From: [REDACTED]
Sent: 2/06/2024 5:32:30 PM
To: Council Northernbeaches Mailbox
Subject: TRIMMED: Submission regarding DA2023 / 1395
Attachments: Letter of Objection dated 2 June 2024.docx;

Re. DA2023/1395 (1010 – 1014 Pittwater Road, Collaroy NSW 2097) Re-Notification

2.6.1 Applicant's 3D drawing (Image 4)

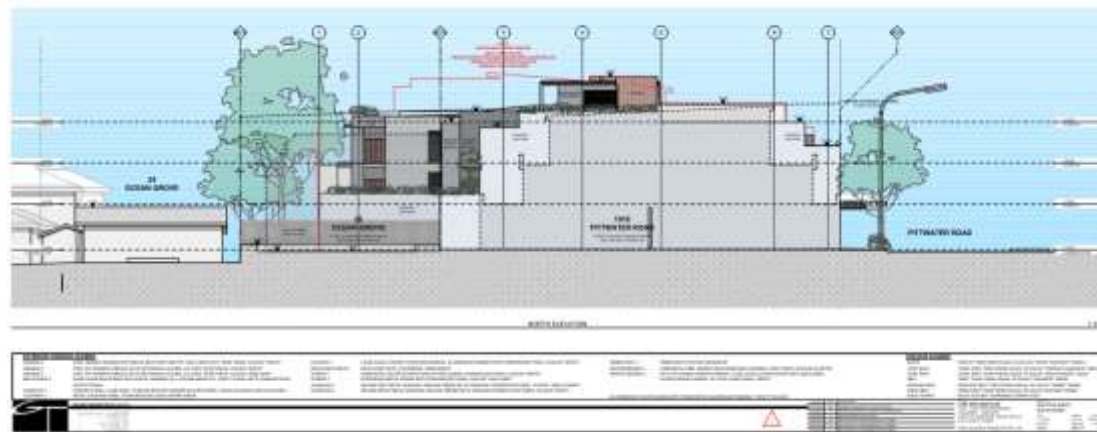
- 2.6 Furthermore, the proposed development also extends, and impairs the outlook, for the neighbouring Unit 1 of 26 Ocean Grove. I produce a copy of the 3D drawing submitted by the applicant, with regards to the claimed potential view from the courtyard of Unit 1, in Section 2.6.1 below.

- 2.6.2 In the context of the development continuing towards the left of my courtyard, adjacent to Unit 1, I wish to highlight the fact that my outlook as presented in the applicant's 3D drawing in Section 2.1.1 above is inaccurate. The applicant's 3D drawing presents a view that my **outlook towards the Southeast corner will be dominated by blue sky**. However, as can be seen from the photograph shown in Section 2.2.1 above, my current direct frontal view from my living room door illustrates that I am not able to see the sky in the Southeast. To observe the sky in the Southeast, should the development proceed, one would have to stand at the living room door in an extreme right corner and remain there. This is unreasonable. The applicant appears to acknowledge this would be the 'spot for outlook' as is sighted by the 'blue outlook arrow' drawn on page four of the Amended Plan.

2.7.1.2 Copy of page 17 of the Amended Plan (Image 5)

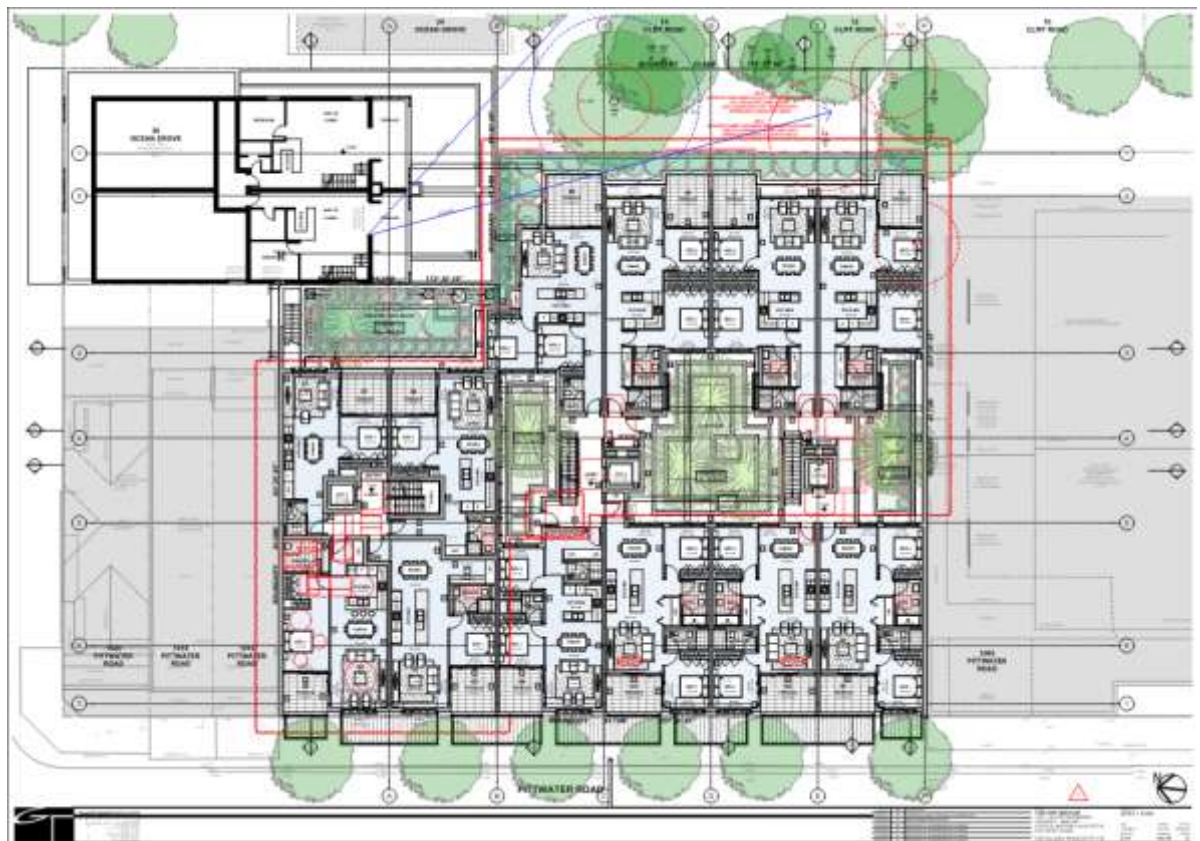
- 2.7.1.1 The proposed development borders both sides of my property and, combined with inadequate side setbacks at all levels of the subject site, presents a serious overshadowing concern. As outlined above, the likely impact upon my outlook arising from the scale, setback, height, and depth of the development is significantly more adverse than shown in the applicant's 3D drawings. The proposed development would enclose and overshadow my property along both sides; resulting in myself not being able to observe the natural sky, from both the frontal views of my courtyard and my living room. I refer to page 17 ('North Elevation') of the Amended Plan to illustrate the magnitude of this towering site upon my property, which the applicant's 3D drawings of my claimed outlook do not adequately capture.

2.7.1.3 The importance of sky visibility is key to the outlook of my apartment. The applicant seems to acknowledge this on page two of their 'Schedule of Amendments' letter dated 19 March 2024 (hereby referred to as "applicant's letter dated 19 March").

4.1.4 Copy of page four of the Amended Plan (Image 7)

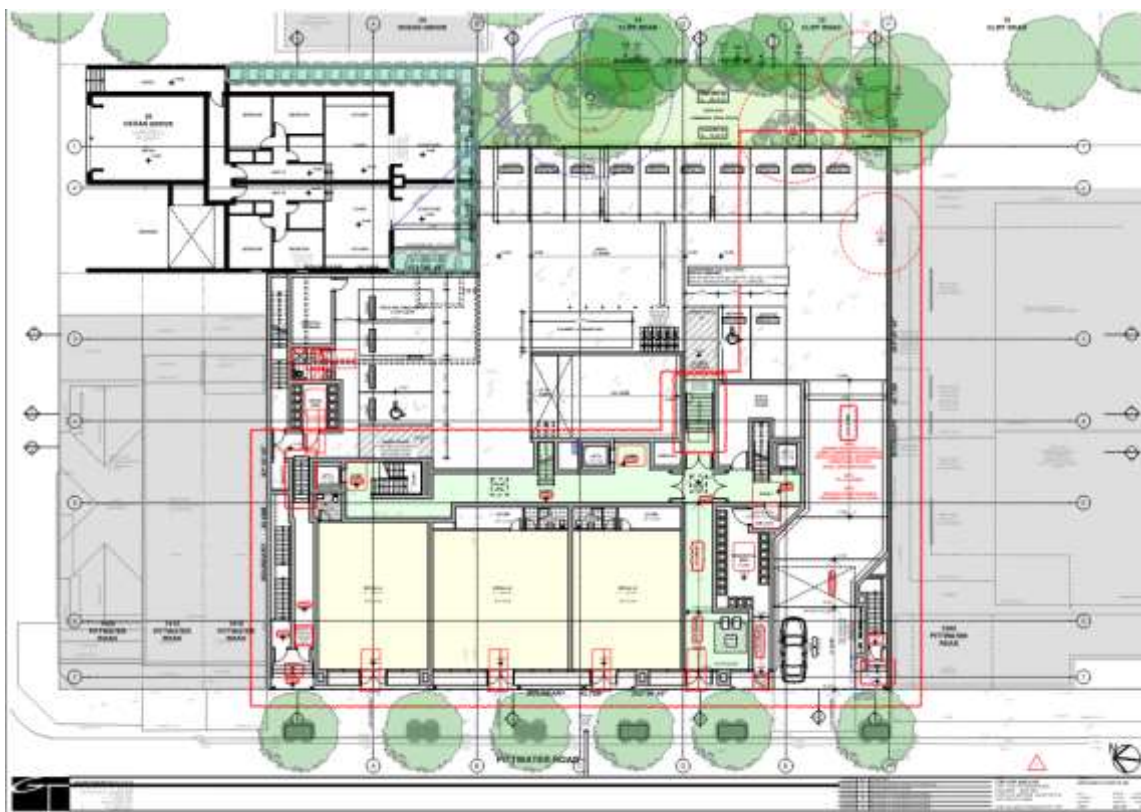
4.1.3 I refer to page four ('Ground Floor Plan') of the Amended Plan, copy produced in Section 4.1.4 below, where the applicant has proposed the complete blocking of my window located in the bedroom of my property. This is completely unacceptable. The applicant's plan will permanently close off my bedroom window, which is critically important for solar access to the interiors of my apartment. Furthermore, this bedroom is being utilised throughout the

entire day as a home office. The Amended Plan will therefore destroy my amenity, in the pursuit of placing a 'Storage room' on the other side. Being one of only two windows in my apartment, this proposal presents an extreme severing of 50% of light from the windows in my apartment.
